# HISTORIC AND DESIGN REVIEW COMMISSION

February 06, 2019

**HDRC CASE NO:** 2019-027  
**ADDRESS:** 6175 OLD PEARSALL RD/MILLERS POND PARK  
**LEGAL DESCRIPTION:** NCB 15250 BLK LOT P-46B  
**ZONING:** R-6  
**CITY COUNCIL DIST.:** 4  
**APPLICANT:** Mark V Padilla/MP Studio Landscape Architecture  
**OWNER:** City of San Antonio  
**TYPE OF WORK:** Park improvements  
**APPLICATION RECEIVED:** January 18, 2019  
**60-DAY REVIEW:** March 19, 2019

4 FISHING PIER ELEVATION

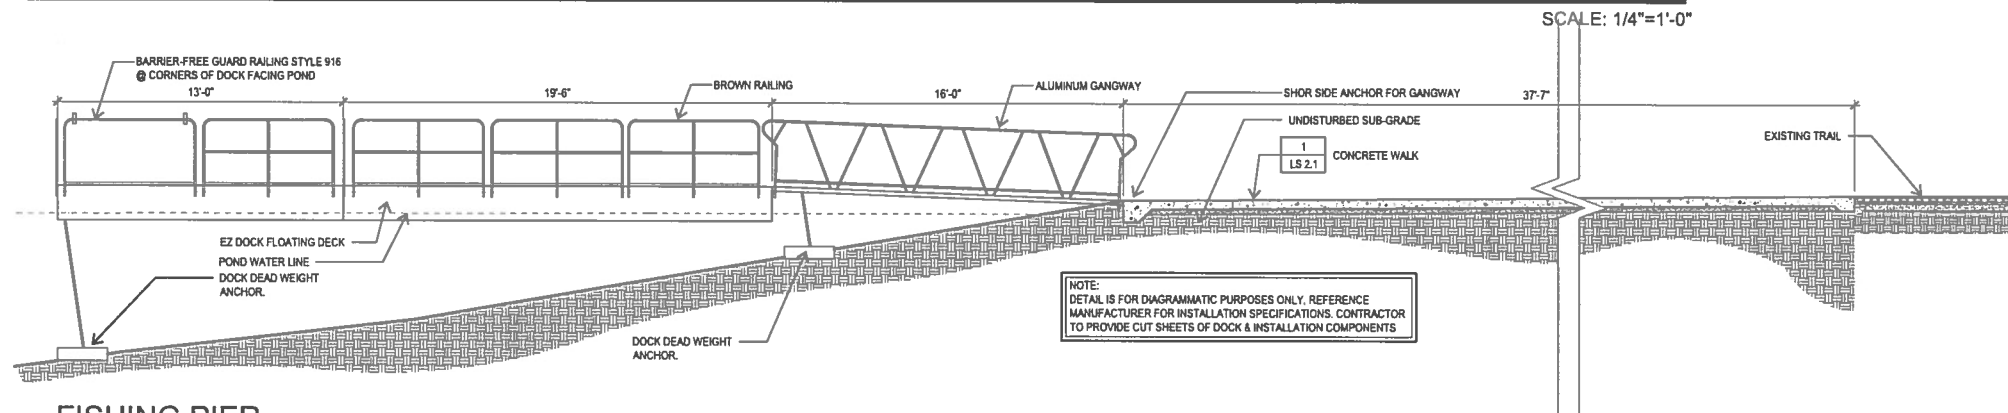
- e. FISHING PIER – The applicant has proposed to construct an ADA accessible floating fishing pier to be installed in an existing pond within the park. Staff finds the proposal generally consistent with the UDC.

DWG.  
**CON-JUN-037-17**

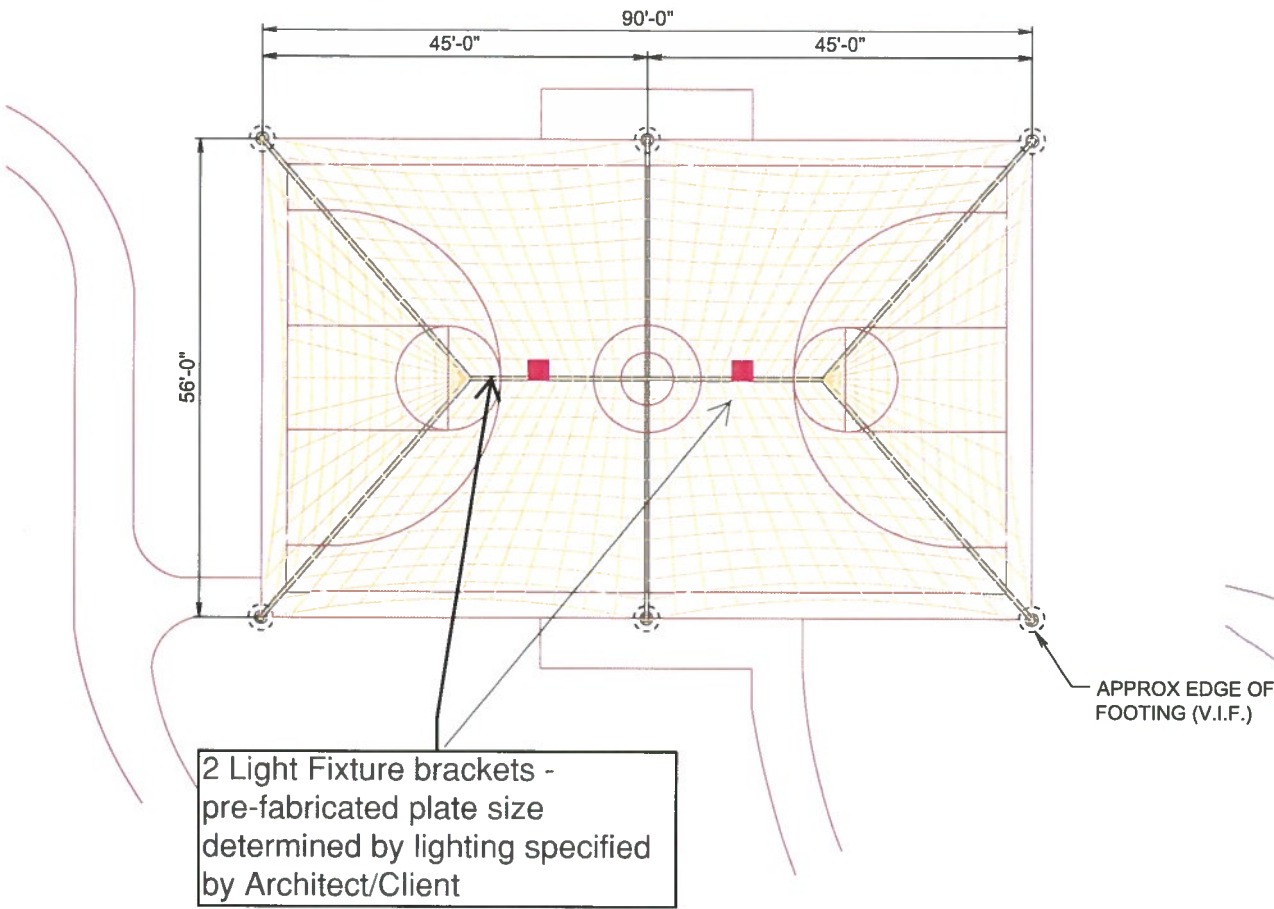
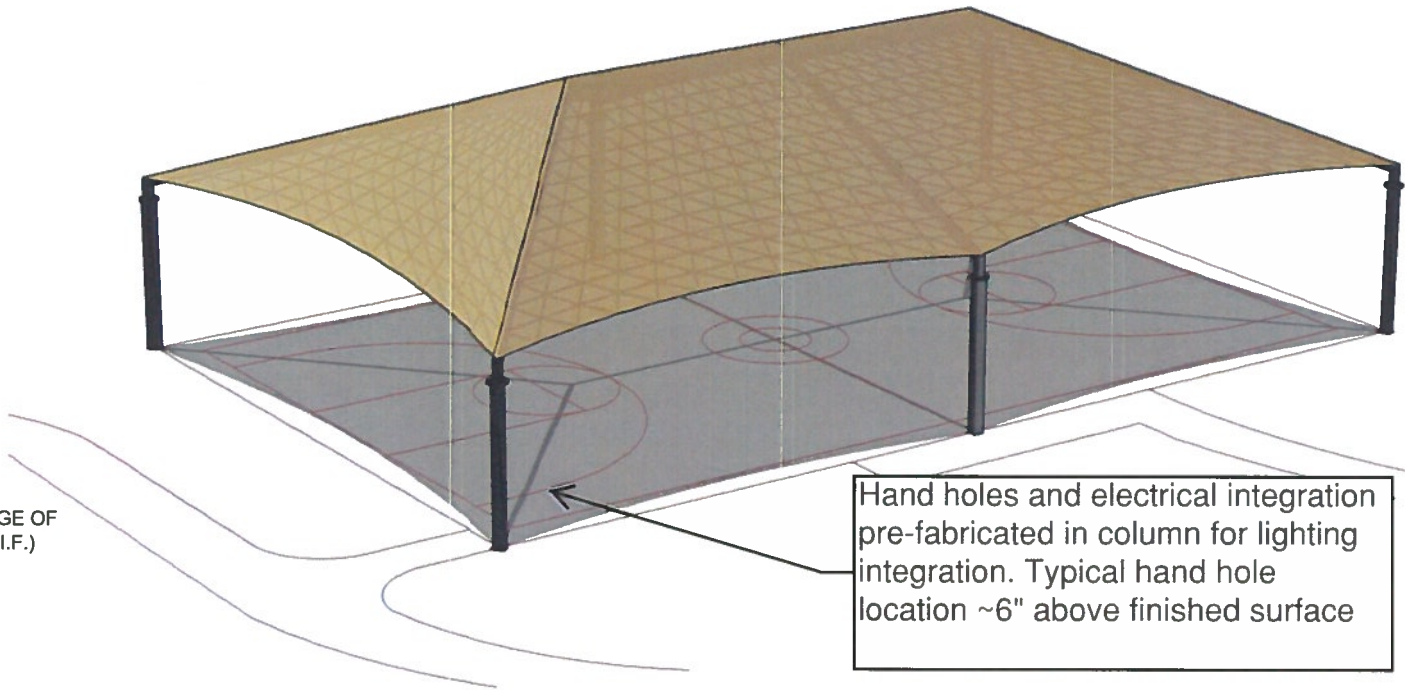
- b. SHADE STRUCTURE – The applicant has proposed to construct a shade structure to cover an existing basketball court. The shade structures will feature metal and fabric canopy elements supported by a metal superstructure. Staff finds the proposal consistent with the UDC Sec. 35-642 (b).
